8923 BLAYDON DR

RE: Property located at 8923 Blaydon Drive, Lot 35
FILE: 678B/8549A
PARCEL: 139-222-17

MECKLENBURG COUNTY ENVIRONMENTAL HEALTH
SITE EVALUATION REPORT
SERIAL NUMBER 12862

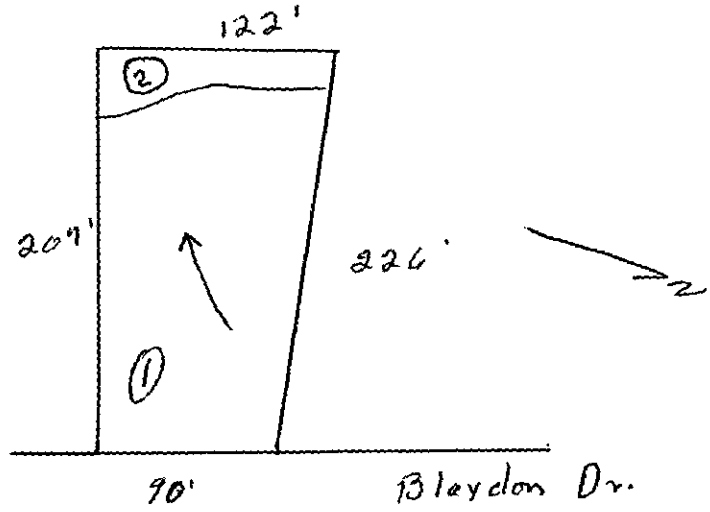
Comments: .3 gal/ft²/day LTAR

FACTORS	AREA 1	AREA 2	AREA 3	AREA 4	AREA 5	AREA 6
Topography	(S) PS U 6-10%	S PS (U) Complex Slopes	S PS U	S PS U	S PS U	S PS U
Texture	S (PS) U Slightly Expansive clay	S PS U	S PS U	S PS U	S PS U	S PS U
Structure	S (PS) U Sub-Blocky	S PS U	S PS U	S PS U	S PS U	S PS U
Drainage	S (PS) U 7 39" TV Water	S PS U	S PS U	S PS U	S PS U	S PS U
Depth	S (PS) U 739"	S PS U	S PS U	S PS U	S PS U	S PS U
Restrictive Horizons	S (PS) U 739"	S PS U	S PS U	S PS U	S PS U	S PS U
Available Space	S (PS) U limited	S PS U	S PS U	S PS U	S PS U	S PS U
Other (specify)	S PS U	S PS U	S PS U	S PS U	S PS U	S PS U
Soil Group/Series	IV Georgeville Silt Loam	Complex Slopes				
Area Classification	S (PS) U	S PS (U)	S PS U	S PS U	S PS U	S PS U

MECKLENBURG COUNTY ENVIRONMENTAL HEALTH
SITE EVALUATION REPORT
SERIAL NUMBER № 12862

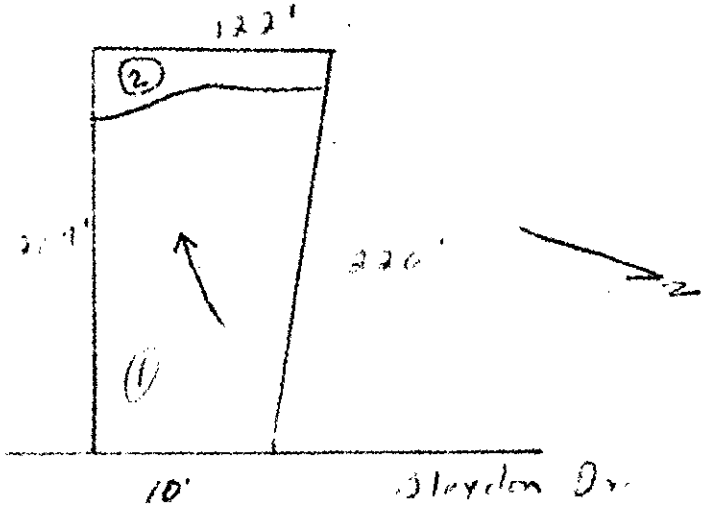
Comments: 3 bdrm/1 1/2 bath, 1 car gar.

FACTORS	AREA 1	AREA 2	AREA 3	AREA 4	AREA 5	AREA 6
Topography	(S) PS U 6-10%	S PS (U) Complex Slopes	S PS U	S PS U	S PS U	S PS U
Texture	S (PS) U Silty Clay Loam	S PS U	S PS U	S PS U	S PS U	S PS U
Structure	S (PS) U Sub Angular Blocky	S PS U	S PS U	S PS U	S PS U	S PS U
Drainage	S (PS) U 73" to wet.	S PS U	S PS U	S PS U	S PS U	S PS U
Depth	S (PS) U 73"	S PS U	S PS U	S PS U	S PS U	S PS U
Restrictive Horizons	S (PS) U 73"	S PS U	S PS U	S PS U	S PS U	S PS U
Available Space	S (PS) U limited	S PS U	S PS U	S PS U	S PS U	S PS U
Other (specify)	S PS U	S PS U	S PS U	S PS U	S PS U	S PS U
Soil Group/Series	LK Georgeville Loam	Complex Slopes				
Area Classification	S (PS) U	S PS (U)	S PS U	S PS U	S PS U	S PS U
